SERVICE BULLETIN REVISION NOTICE

ENGINE FUEL AND CONTROL — PROVIDE A NEW ELECTRONIC ENGINE CONTROL (EEC)
WITH SCN21/AA SOFTWARE

Turbojet Engine Service Bulletin No. V2500-ENG-73-0222 Revision No. 2 dated April 18, 2019.

To add the new EEC Software Loader (ESL), Tool No. IAE2P16613 and SD Card PNs 1018294-6 and 1018294-7.

LOCATION OF THE ELECTRONIC ENGINE CONTROL
73-22-34
FIGURE 1

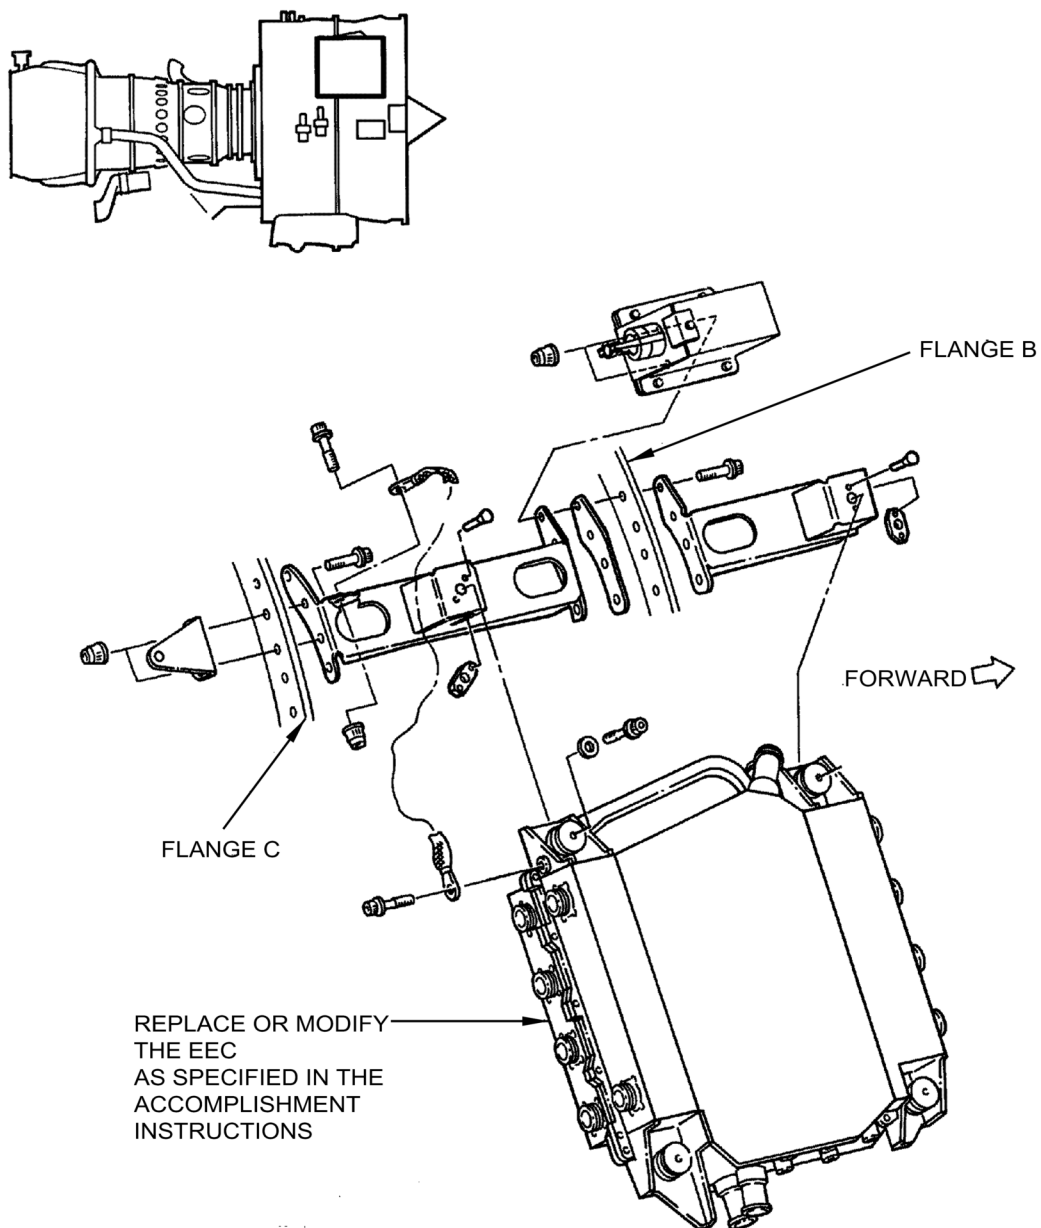
1. Remove the EEC as specified in Reference 3, Aircraft Maintenance Manual, Chapter/Section 73-22-34, Task 73-22-34-000-010. See Figure 1 for the location of the part.
2. Replace the old EEC with a new one as specified in the Material Information Section.

- A. Open the nacelle and prepare the aircraft for servicing as specified in Reference 3, Aircraft Maintenance Manual, Chapter/Section 73-22-34, Task 73-22-34-000-010. See Figure 1 for the location of the part.
- B. Remove the EEC harness connector from J1, J3, J7 and J9.
- C. If desired, remove the EEC as specified in Reference 3, Aircraft Maintenance Manual, Chapter/Section 73-22-34, Task 73-22-34-000-010. See Figure 1 for the location of the part.

- B. Verify that the model number on the identification plate of the unit is "EEC 150-20" or "EEC 150-40". See Figure 1 for the location of the part.
- C. If desired, remove the EEC as specified in Reference 3, Aircraft Maintenance Manual, Chapter/Section 73-22-34, Task 73-22-34-000-010. See Figure 1 for the location of the part.
